Catherine Field (part) Precinct

Post Exhibition Transport and Access Review (Addendum)

Client: Department of Planning & Infrastructure (on behalf of Hixson Pty Ltd)

24-Oct-2013

Figure 14: Bus Strategy for Catherine Field (part) Precinct

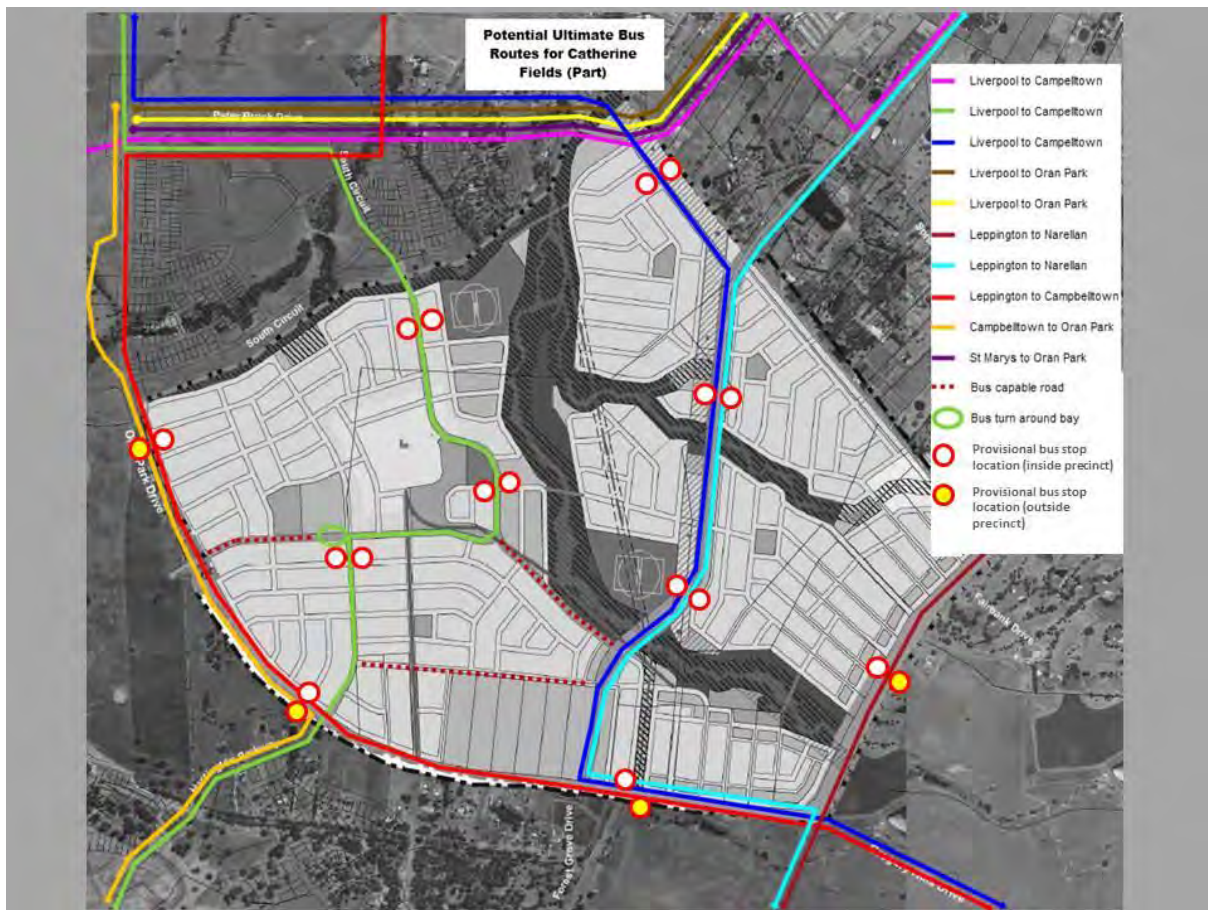
The exhibited bus strategy for the precinct has been revised by TfNSW following exhibition. The proposed routes are shown in **Figure 14**. This shows that bus routes will be oriented toward Oran Park (to reflect a proposed bus hub located in the Oran Park Town Centre), however there will also be a direct connection between the Precinct and Leppington Town Centre/Station along the full length of Rickard Road.

Within the precinct itself, two services will operate along Rickard Road, while one will operate through the west of the precinct via South Circuit, Dan Cleary Drive and Harrington Parkway. This service also proposes a bus turnaround facility within or adjacent to the proposed school (on the corner of Harrington Parkway and Dan Cleary Drive) enabling school buses to operate more efficiently. This is shown as a loop in **Figure 14**.
